SUBJECT: TELECON OF 12/07/81 REGARDING JANUARY 5, 1982 HEARING ON  
MIDLAND SOILS

FACILITY: Midland Plant, Units 1 and 2

APPLICANT: Consumers Power Company  
FACILITY: Midland Plant, Units 1 and 2  
SUBJECT: SUMMARY OF JANUARY 12, 1982 MEETING ON QA ORGANIZATIONAL  
CHANGES AND UNDERPINNING QA

Subject: Staff Review Schedules for Soils Remedial Actions  
for Midland Plant, Units 1 and 2

# AUXILIARY BUILDING UNDERPINNING FEEDWATER ISOLATION VALVE PIT SECTION VIEW OF SUPPORT

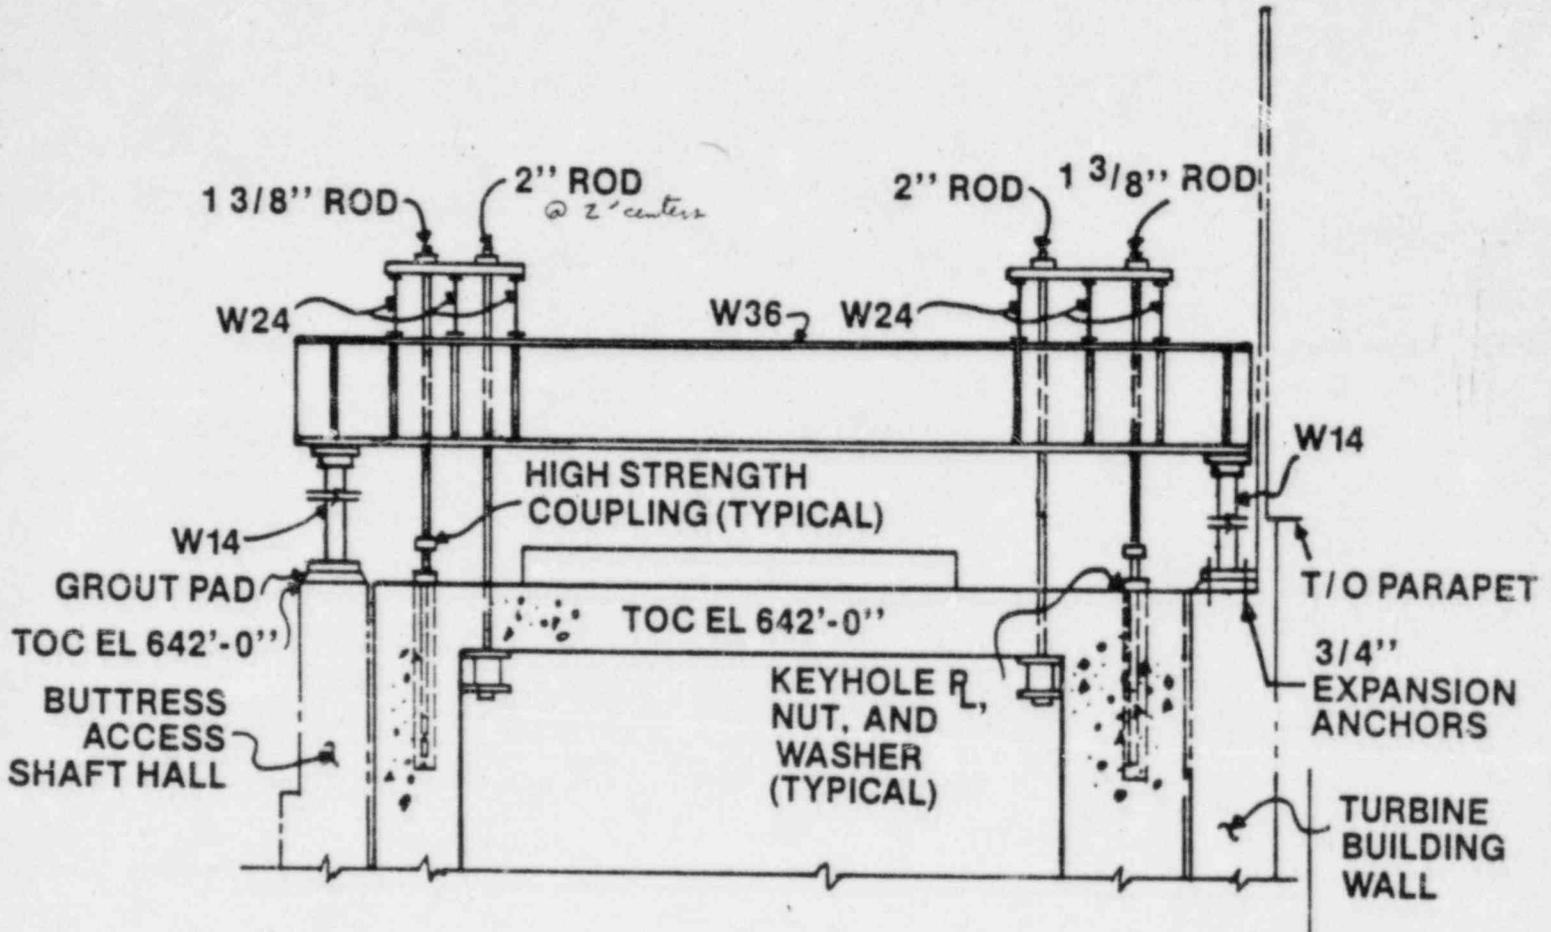
The applicant's criteria for settlement of the FIVP is 1/2" vertical movement and 1/8" horizontal. The values are based upon stress in the main feedwater pipe (see FSAR Figure 3.8-18) and were arbitrarily selected (i.e., a higher value could possibly have been selected for the analysis and found acceptable). The 1/2" criterion was determined to result in 9324 psi stress at the anchor point of the feedwater pipe, which is well within allowable stresses for a no-break criterion. A criterion of 3/16" was set during the load transfer of the FIVP to its temporary supports during early May 1981 and is included in the 1/2" criterion. However, the staff found that total settlement since the piping was first installed in 1977 was not known nor included in the calculated stress, and this represented an open item.

**AUXILIARY BUILDING UNDERPINNING**

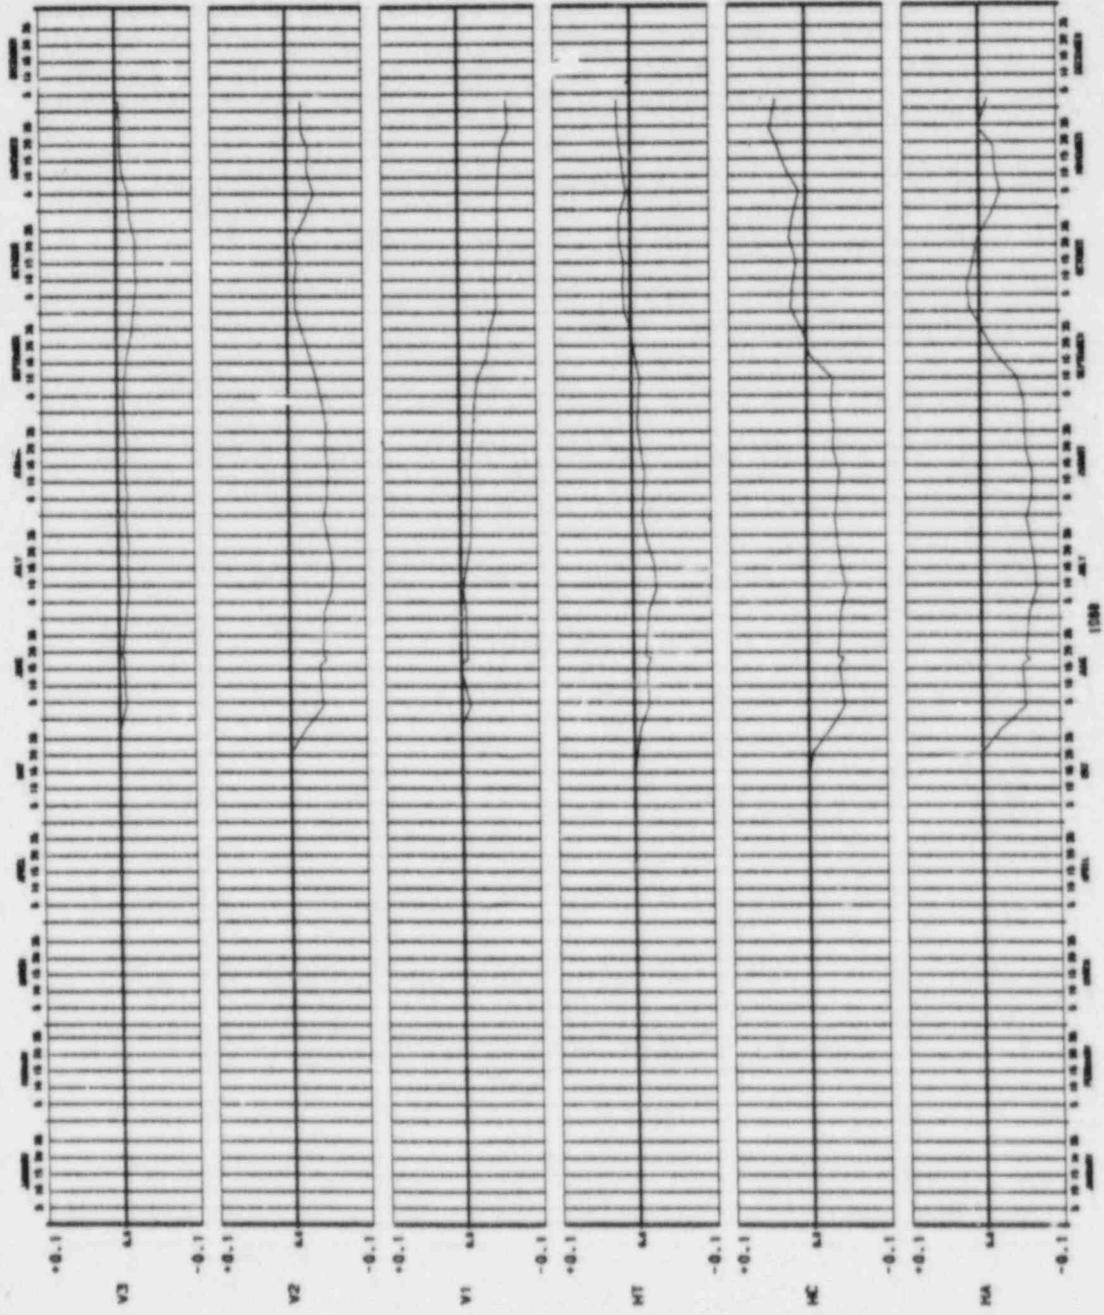
- **FIVP MONITORING PART OF OVERALL UNDERPINNING PROGRAM**
- **REJACK FIVP WHEN SETTLEMENT APPROACHES 3/8 INCH**
- **CRACK MAP FIVP BEFORE AND AFTER EACH MAJOR CONSTRUCTION ACTIVITY AFFECTING FIVP**
